TECHNICAL REPORT

Rocker cover gasket for 2.0
CRDI D4EA 112CV engines part
number: 56031000 & 56037500

56031000

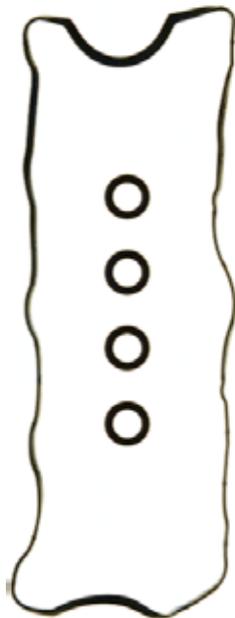
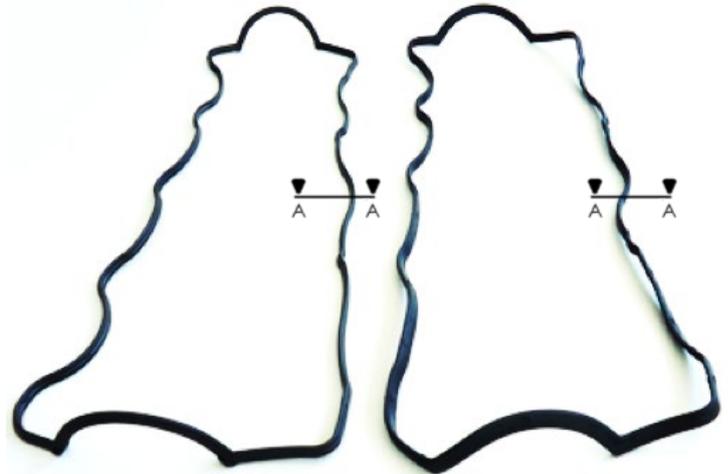
Such rocker covers are very similar in shape and design, but there are some **dimensional differences** in the housing where the gasket fits in. Therefore, if you don't choose the gasket correctly, it will not fit well in the cover, leading to an oil leakage.

As can be seen in the previous images, the gaskets sections differ to a large extent.

For that reason, it is crucial to choose the right gasket to install according to the model and manufacturing year of the vehicle.

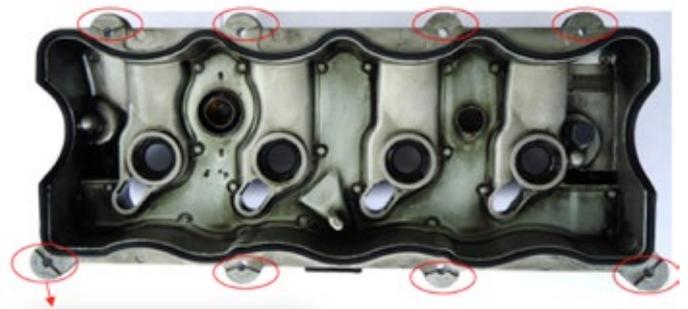
The rocker cover has some mechanical stops that rest on the cylinder head and limit the distance between the rocker cover and the cylinder head. Those mechanical stops accomplish two main goals:

- To limit the closing pressure to avoid gasket damage.
- To homogenize the closing pressure against the cylinder head.

In case of installing **set 56031000** in the wrong rocker cover, as the gasket has a lower height, it will remain below the mechanical stops and it won't seal over the cylinder head. As a result, a remarkable oil leakage will occur.
